MODIFICATION No. 23554P3127

TITLE : AIR CONDITIONING - COCKPIT - INTRODUCE PROTECTION AGAINST WATER CONDENSATION.

SERVICE BULLETIN No. : A320-21-1072

Installation of the Seal on the Lower Part of the Sliding Window Easings
 Figure 7

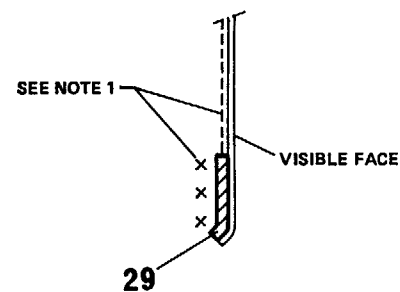
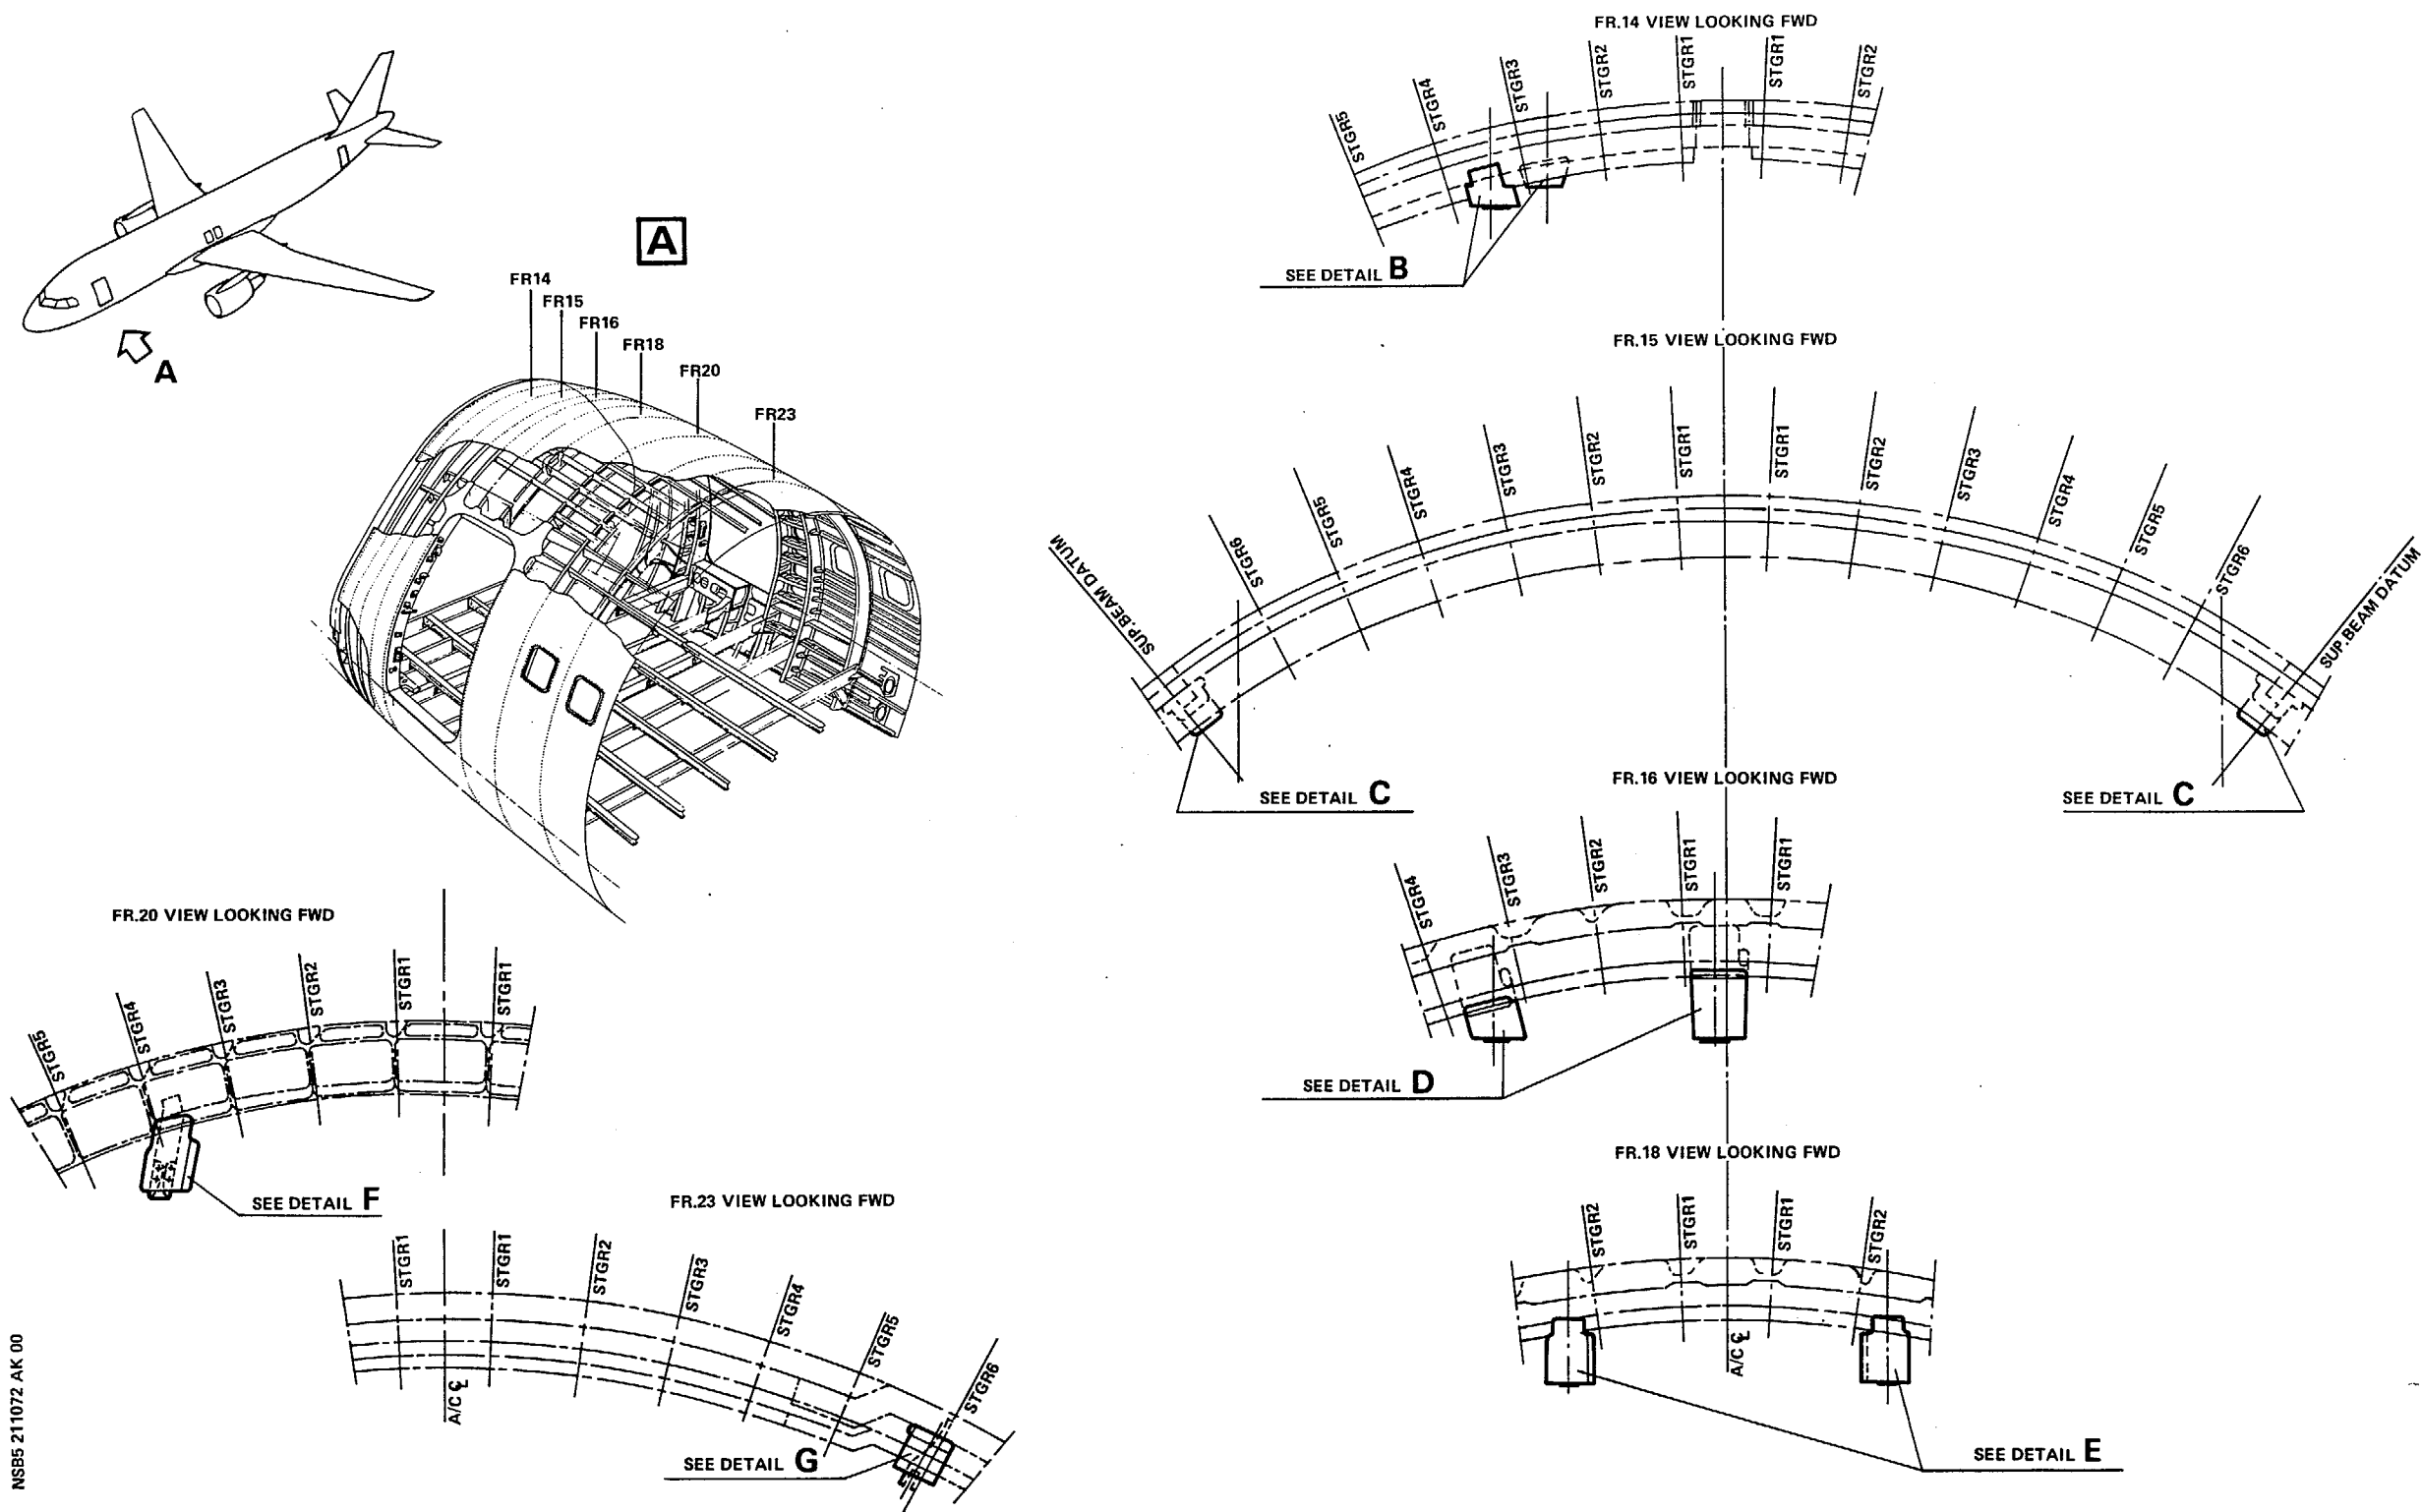
- (7) Installation of the seal on the lower part of the sliding window easings

- (b) Refer to the specified dimensions and install :

D2511105300200 Item (33) becomes D2511158400000 Item 33.

D2511105300300 Item (34) becomes D2511158400100 Item 34.

Silicone strip ABS5006-40 Item 29

- (c) Paint the specified area with Mat. No. 16-047 (Ref. CML).

Installation of the Insulation Blankets on the Visible Structures
Figure 8, Sheet 1 of 7

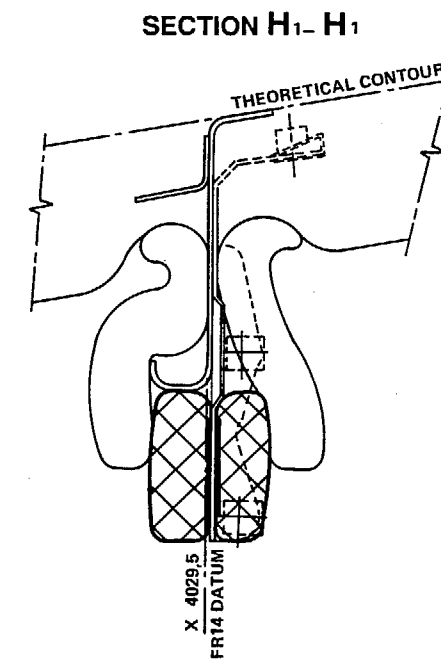
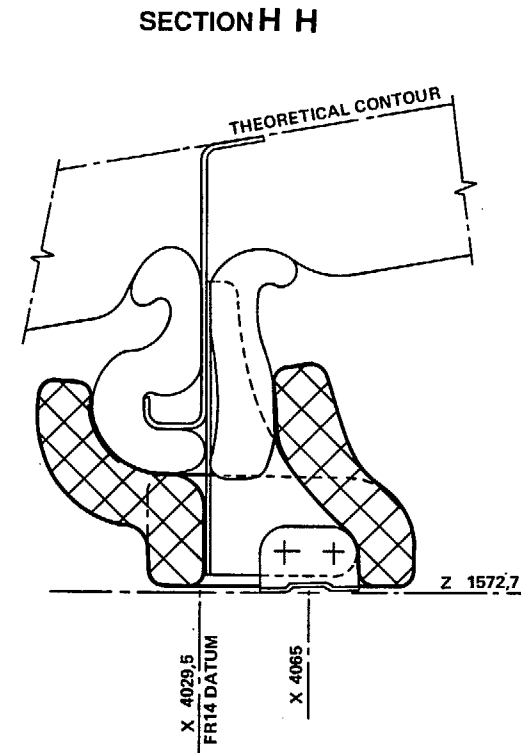
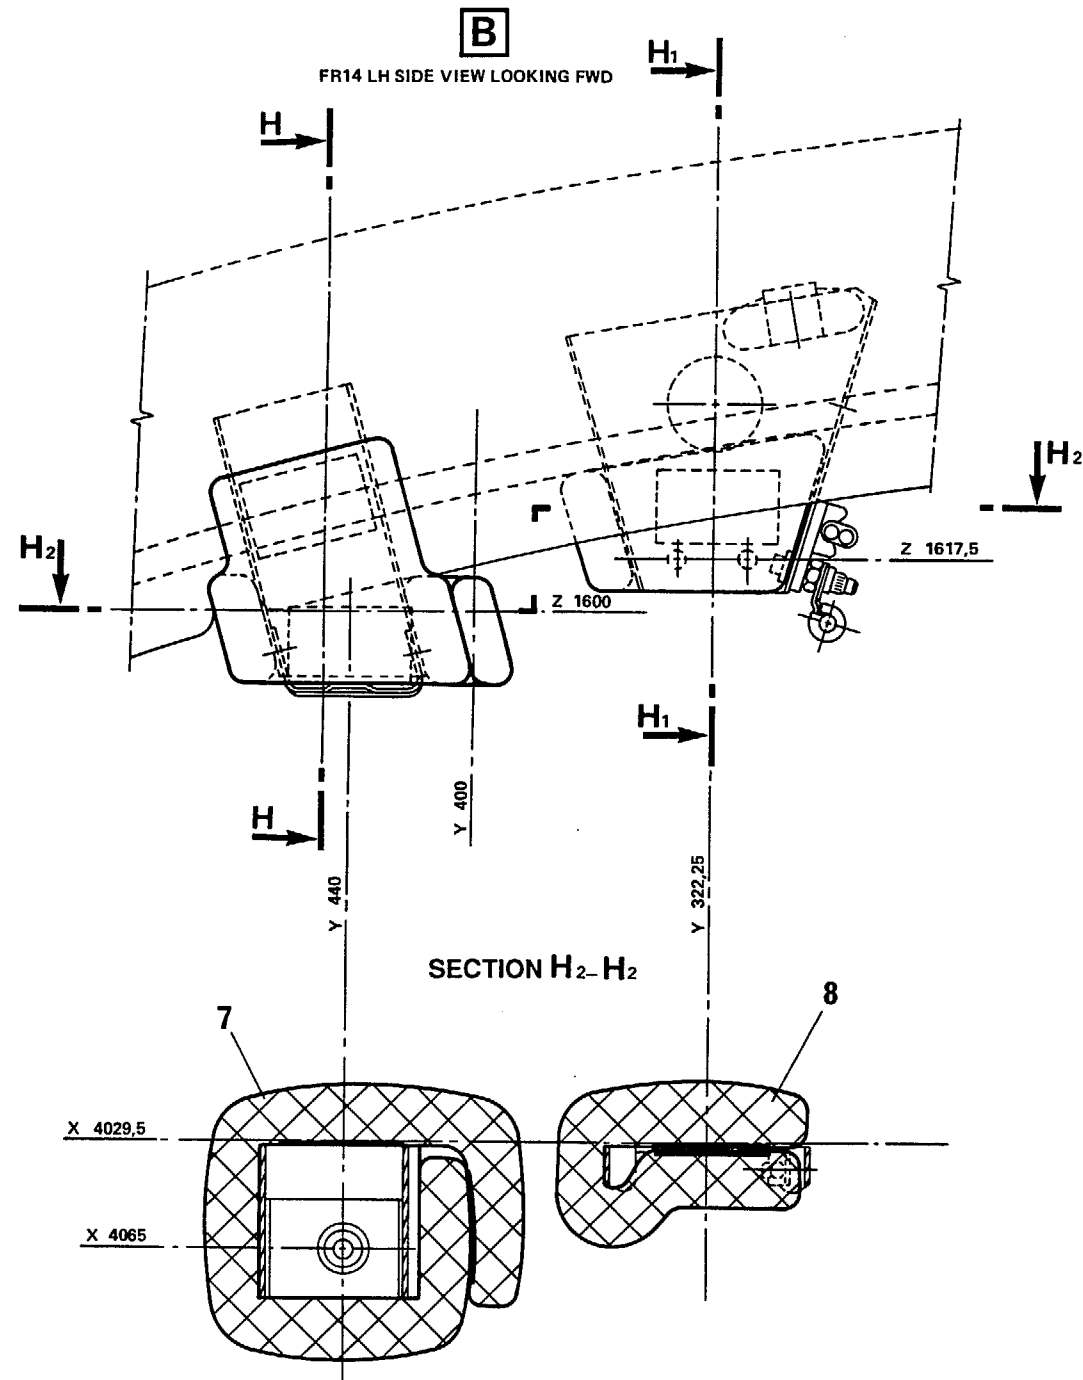
(8) Installation of the insulation blankets on the visible structures

NOTE : These insulation blankets will be attached to the primary insulation by self-adhesive patches.

Installation of the Insulation Blankets on the Visible Structures
Figure 8, Sheet 2

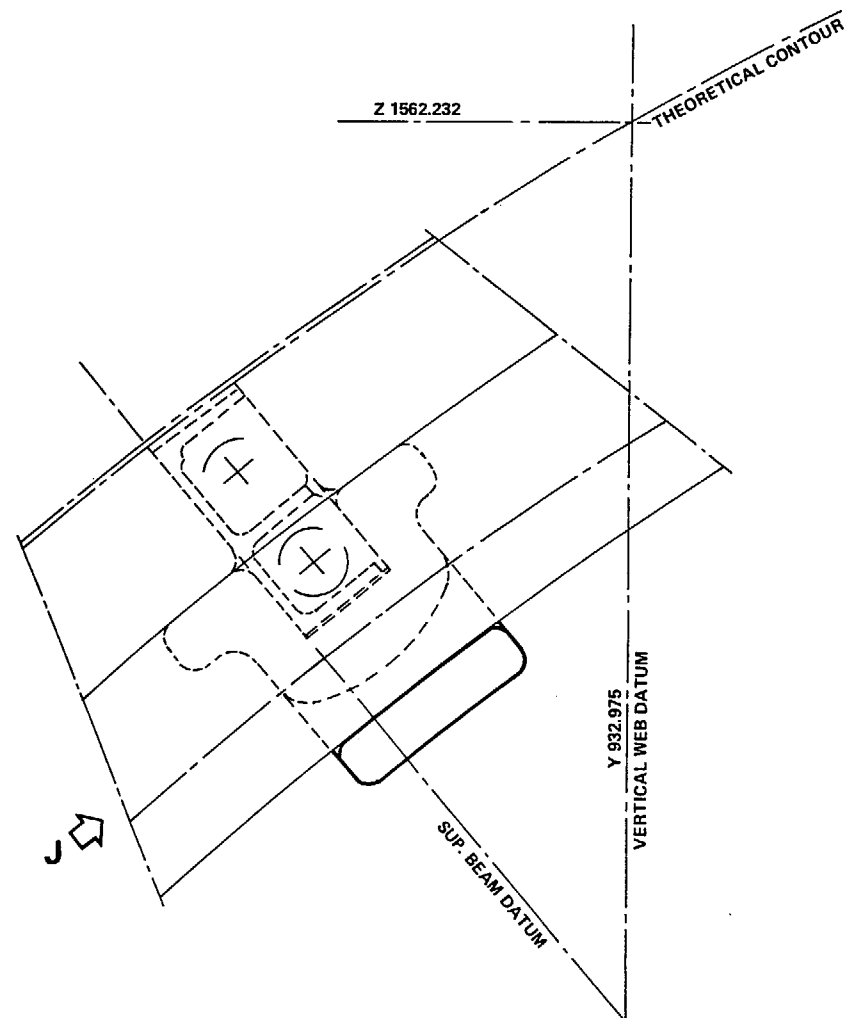
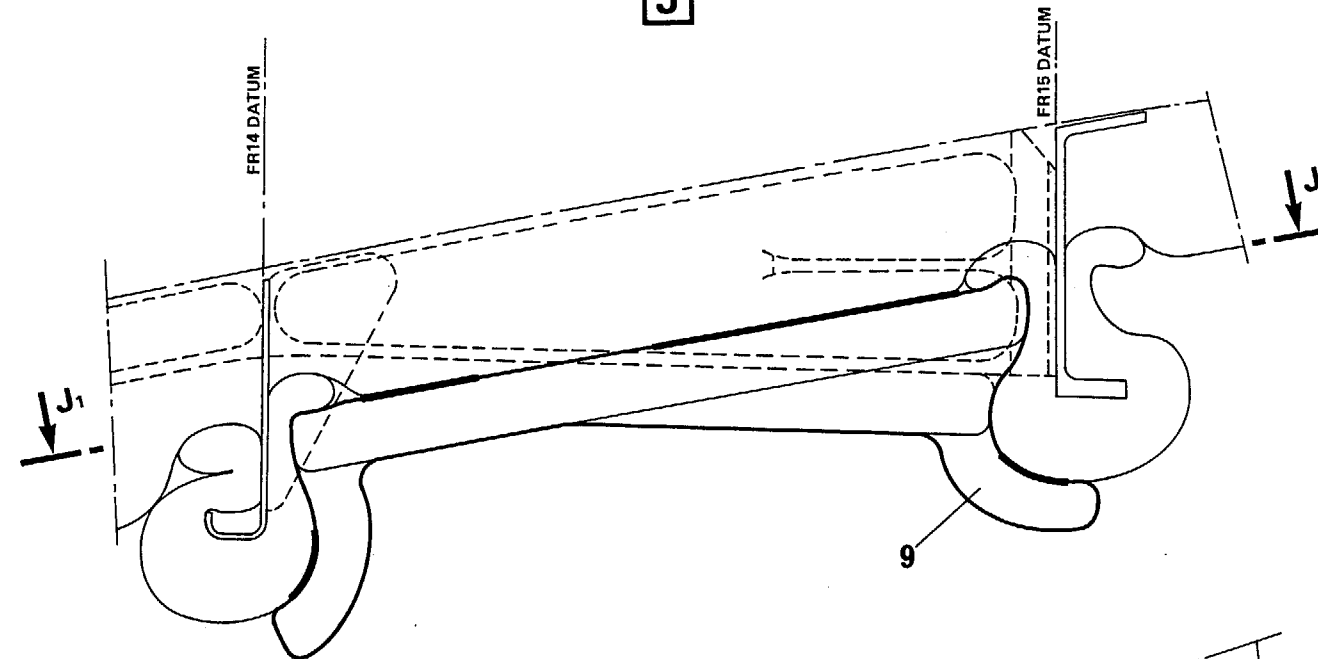
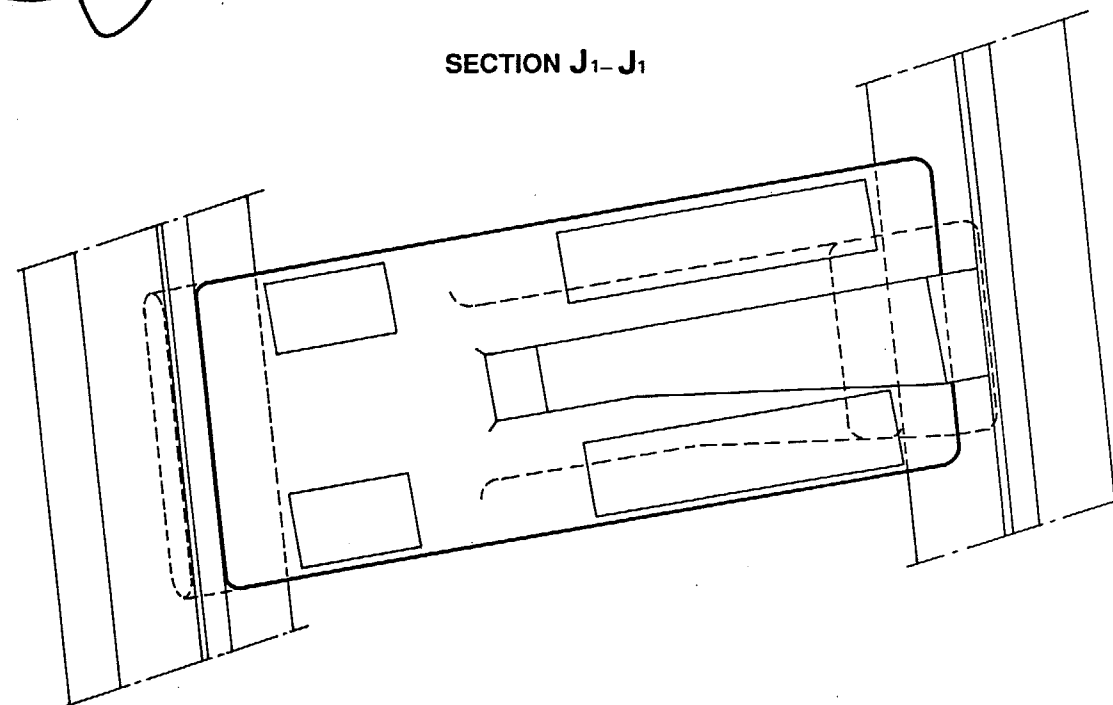
- (a) On the ceiling and trim panel pick-up bracket, at FR14, install :

1 insulation blanket	D2581053400000	Item 7
1 insulation blanket	D2581053500000	Item 8

Installation of the Insulation Blankets on the Visible Structures
Figure 8, Sheet 3

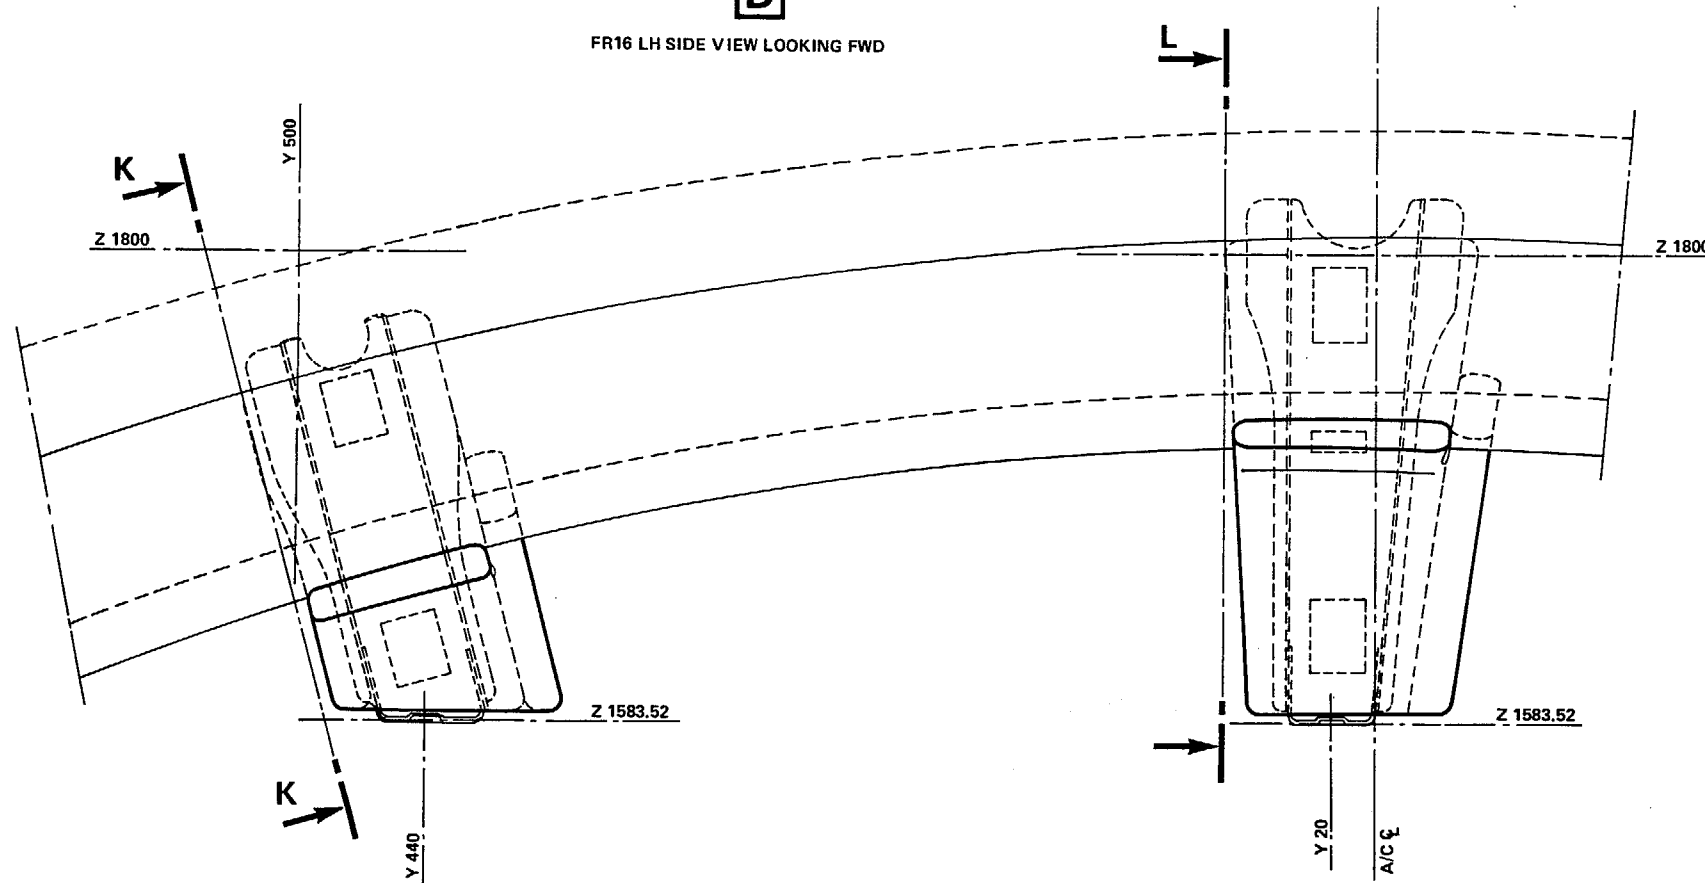
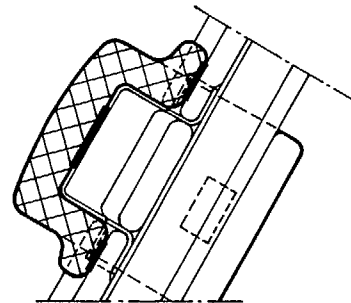
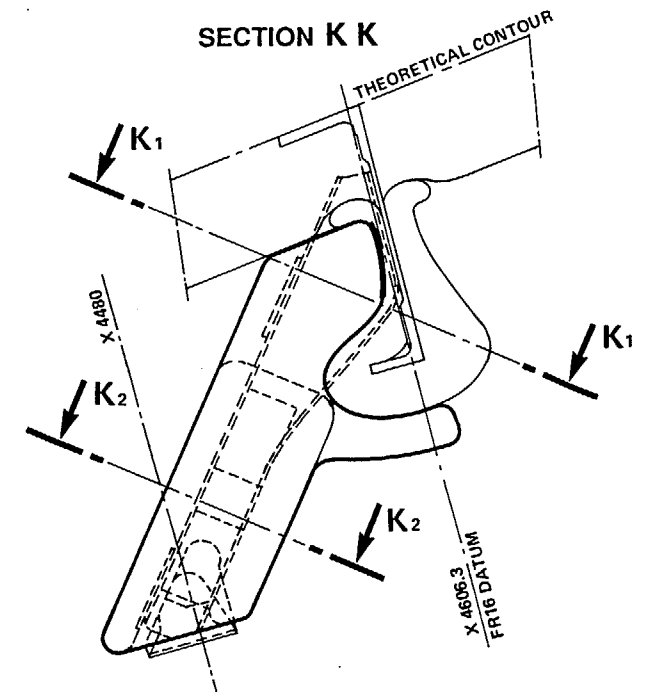
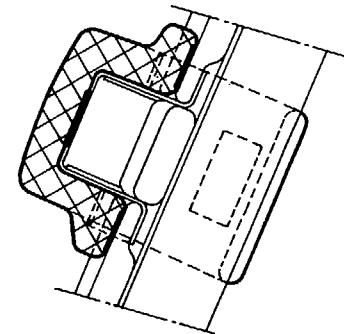
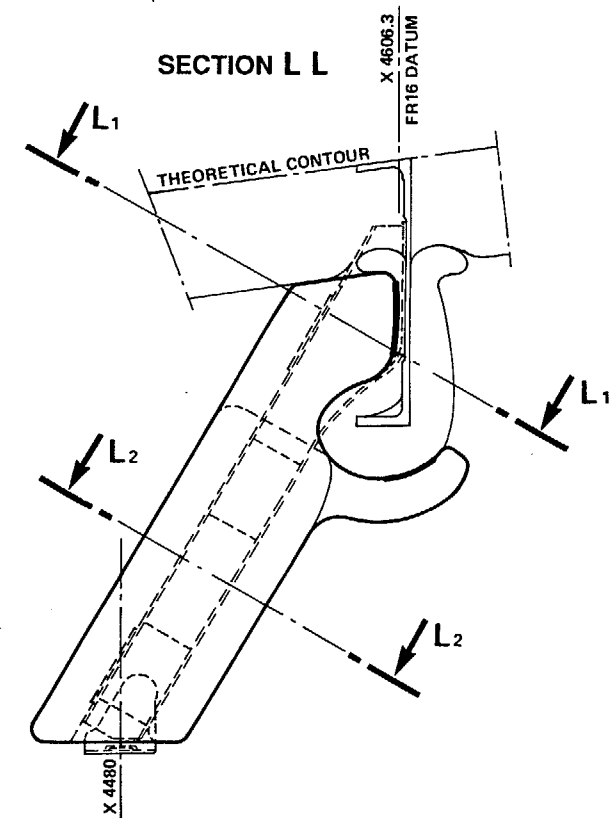
- (b) At the upper passenger door box continuity fittings between FR14 and FR15, install :

1 + 1 insulation blanket	D2581053600000	Item 9
--------------------------	----------------	--------
